Introduction

The Teridian 78Q8392L 10BASE-2 Transceiver IC can be used as a replacement for other industry standard 8392s. However, there are some differences between the Teridian 8392L and competitor's versions of the 8392. This application note describes the differences and required circuit changes, if necessary, to use the 78Q8392L as a replacement for the competitor's device.

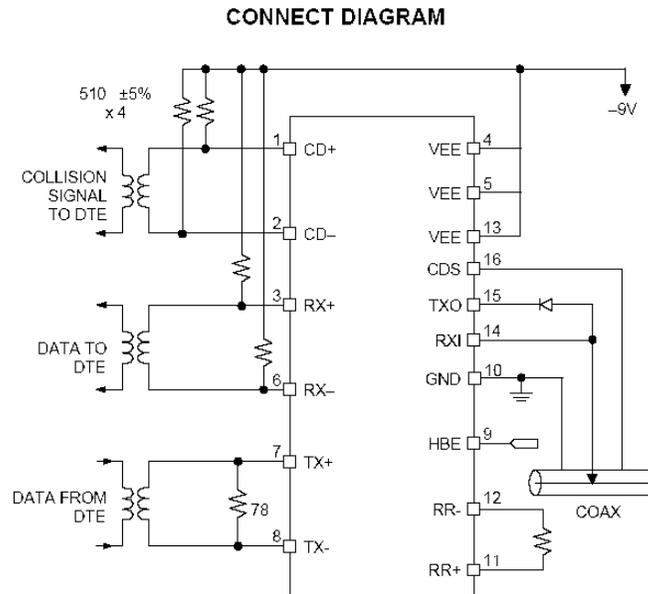
The Teridian 78Q8392L is specified for use with $510\Omega \pm 5\%$ termination resistors on CD+/- and RX+/- . A single $78\Omega \pm 1\%$ termination resistor is required across TX+/- . Refer to the following CONNECT DIAGRAM for the required AUI termination circuitry.

The CD+/- termination resistor may be increased to $1.5K\Omega$ to save power. Refer to the CD+/- pin description in the data sheet for specific information.
